Conjoined Appeal : Broad Oak Farm, Cobbler's Lane, Rossett, Wrexham, LL12 0UA

APP/H6955/A/18/3214586 : Proposed change of use and conversion of barns to form 13 no. residential units and associated works including part demolition (**P/2017/0623**)

APP/H6955/A/18/3214588 : Proposed change of use / conversion / part-demolition of barns to form 5 no. residential units and associated works (**P/2018/0223**)

**OBJECTION ON BEHALF MR AND MRS RIGBY OF
LLYNDIR COTTAGE TO APPLICATION 17/0623**

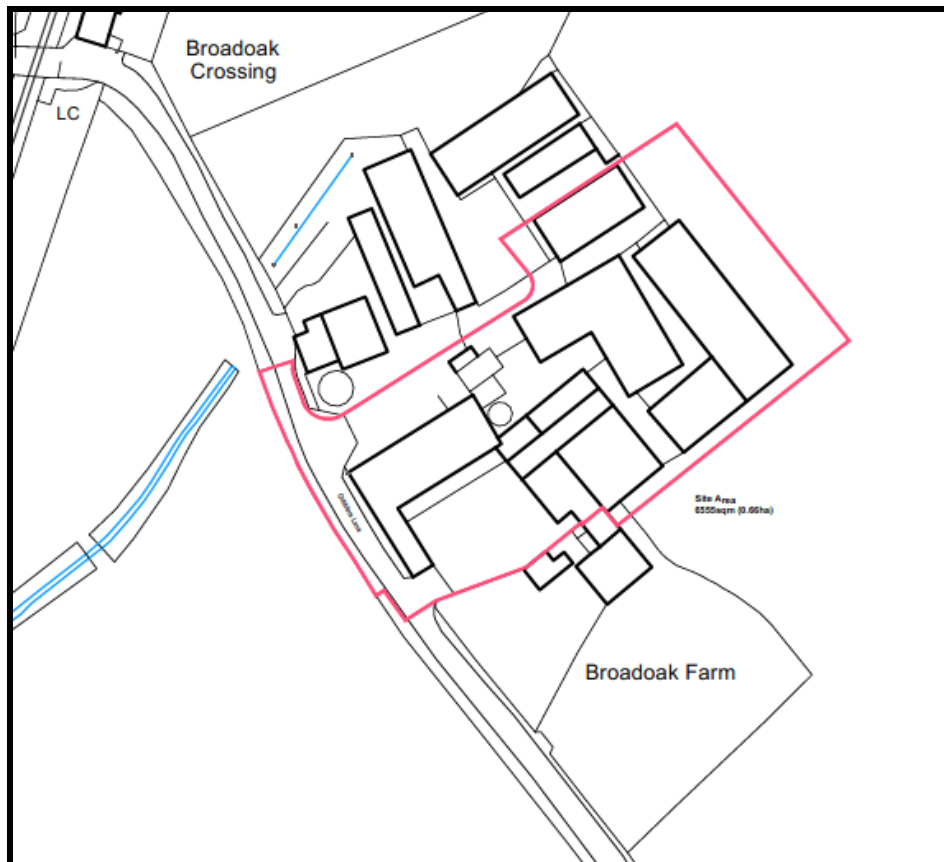
Llyndir Lane: Commences from its junction with Chester Road, this is the more constrained of the two access junctions onto Chester Road. It becomes subject to a national speed limit applies order i.e. 60 mph max speed approx 50 m from the junction. It becomes a narrow width i.e. only one vehicle at a time with limited passing bays.

Beyond the hotel the road narrows further and becomes overshadowed by trees on both sides. Forward visibility is further restricted and no line of sight is available between approaching vehicles.

At the end of the short length of narrow road it turns to the right to form the junction with the unnamed road. This occurs at the location of Llyndir Cottage whose boundary fence restricts forward visibility.

The unnamed road: Starts with a junction onto Chester Road and this is the least constrained of the two junctions.

The speed limit again changes to national speed limit applies as the road narrows. There is a narrow footpath alongside the road defining the edge on the right/northerly side.

The route then turns left via a sharp bend having restricted forward visibility to run alongside the residential properties. At this point the road widens to allow passing but site observation shows that vehicles park here thus restricting passing opportunities.

From the park access towards the junction with Llyndir Lane the road has a ditch on either side and hedges creating a constrained feeling and thus reduces speed. A passing bay is located prior to the junction, advice is given that this also gets parked up on a regular basis.

As indicated the Lane and the unnamed road beyond the Business Park do not have footpaths and pedestrians have to step into the verge/hedges to escape vehicles as they pass.
